Proposal for amendments to Regulation No. 43 (Safety Glazing)

This amendment was prepared to introduce provisions for the case of a vehicle with the driver seated in central driving position.

Figure 1b : Test area “a” (example of central steering control vehicle)

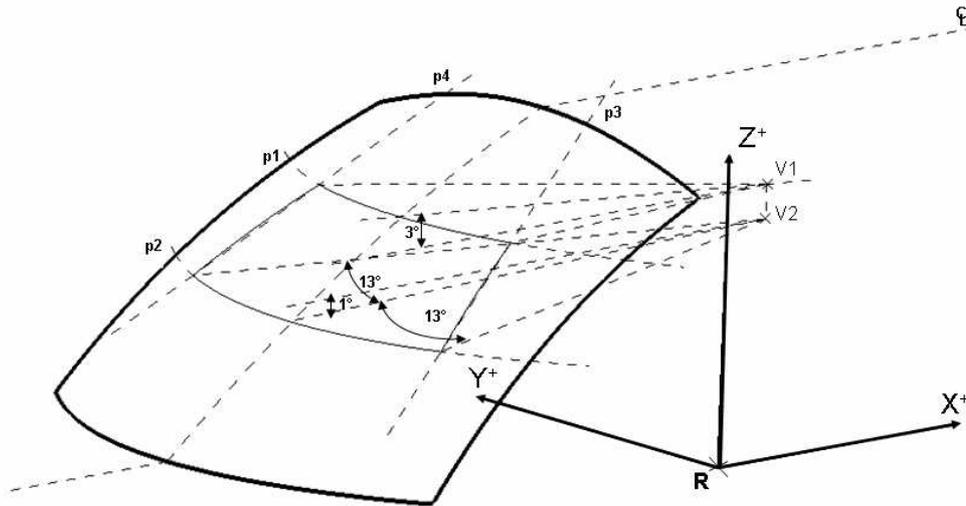
2.2. "Test area A" is the area of the outer surface of the windscreen bounded by the intersection of the following four planes (see figure 1a **and 1b**):

(c) a vertical plane passing through V1 and V2 and inclined at 13° to the left of the X axis in the case of left-hand drive vehicles **and central drive vehicles** and to the right of the X axis in the case of right-hand drive vehicles (plane 3);

(d) a vertical plane (**plane 4**) passing through V1 and V2 and inclined at 20° to the right of the X axis in the case of left-hand drive vehicles, **20° to the left of the X axis in the case of right-hand drive vehicles and 13° to the right of the X axis in the case of central drive vehicles.**”

Insert a new figure 1b, to read:

The current text of regulation does not take into account the case of vehicles equipped with central steering control (within plane Zero Y). In that case, Zone A could be outside zone B if the text is not amended.

The proposal allows to draw the A zone symmetrical inside B Zone if the driver is in a central driving position.
